MODIFICATION INSTRUCTIONS

Kodak X-Omat 180 LP PROCESSOR

Modification No. 3

Purpose: To prevent solution leakage caused by cracked or broken FITTINGS.

H127_0166BCA
H127_0166BA

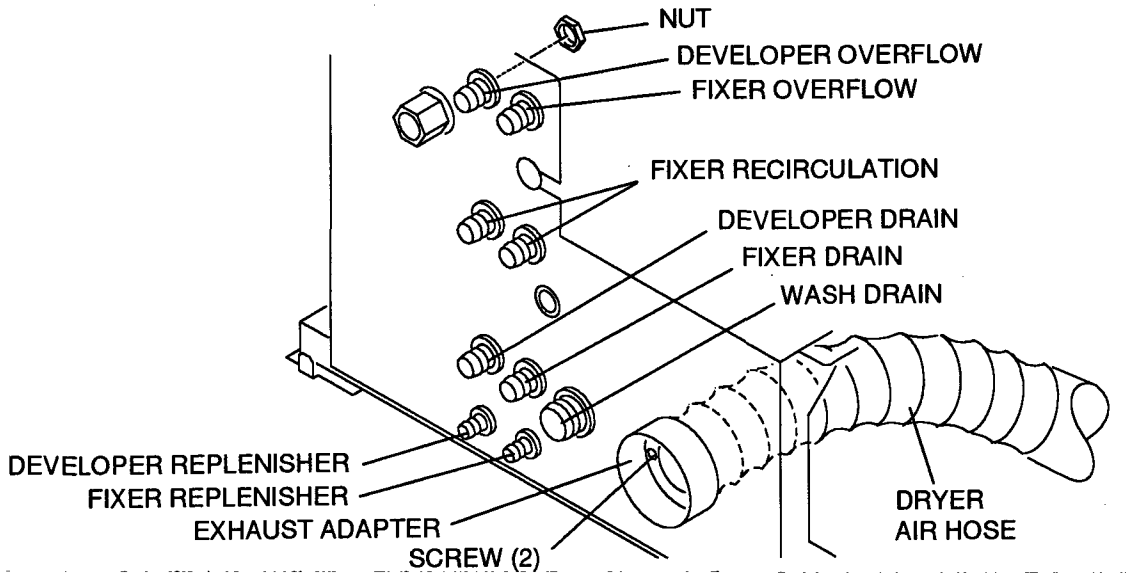
[5] On both sides of the BULKHEAD PANEL, remove the HOSES, NUTS, and existing FITTINGS for the:

- DEVELOPER OVERFLOW
- FIXER OVERFLOW
- FIXER RECIRCULATION

H127_0165ACA
H127_0165AC

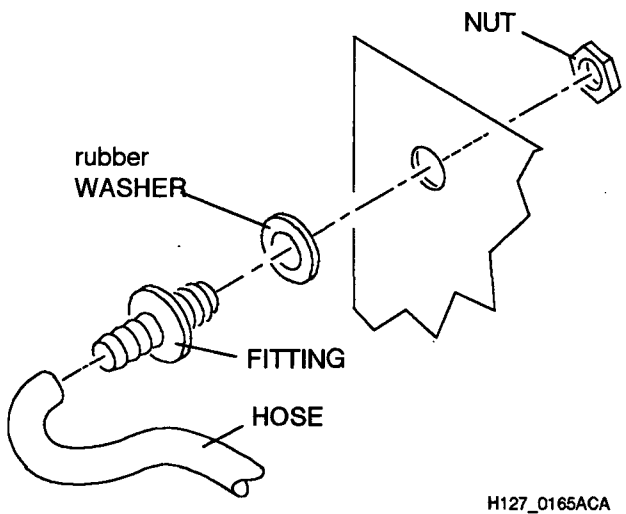
[6] Install the new FITTINGS for the FIXER RECIRCULATION.

(a) Install the rubber WASHERS in the correct position on the FITTINGS. See the figure at the right.

(b) Insert the new FITTINGS through the holes in the BULKHEAD PANEL with the rubber WASHERS between the BULKHEAD PANEL and the FITTINGS.

(c) Install the NUTS on the FITTINGS. Tighten the NUTS **until the NUTS make contact** with the BULKHEAD PANEL.

(d) Tighten the NUTS an additional ¼ rotation to compress the WASHERS.

H127_0173GCA
H127_0173GA

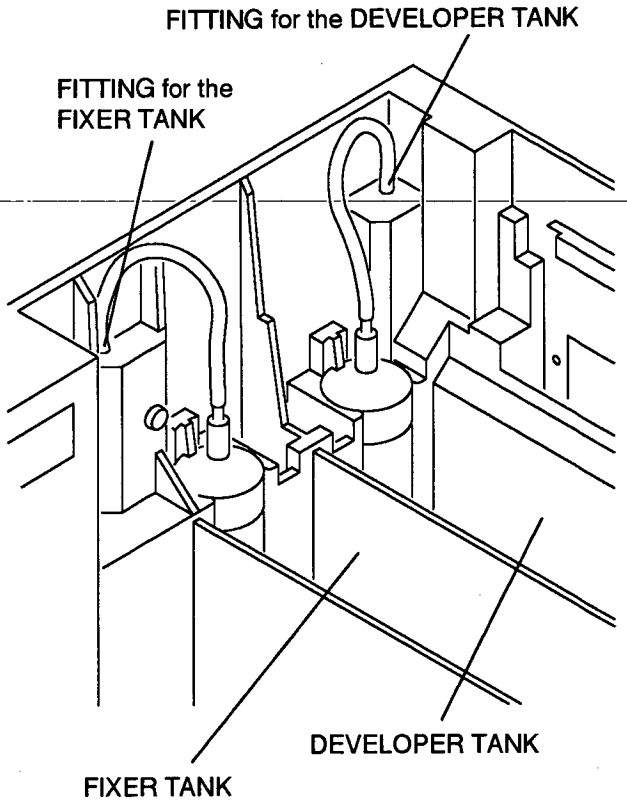
[13] Install the new FITTINGS for the DEVELOPER TANK and the FIXER TANK:

(a) Install the rubber WASHERS in the correct position on the FITTINGS.

(b) Insert the new FITTINGS through the holes in the TANKS with the rubber WASHERS between the TANKS and the FITTINGS. See the figure on page 4.

(c) Install the NUTS on the FITTINGS. Tighten the NUTS **until the NUTS make contact** with the wall of the TANKS.

(d) Tighten the NUTS an additional ¼ rotation to compress the WASHERS.
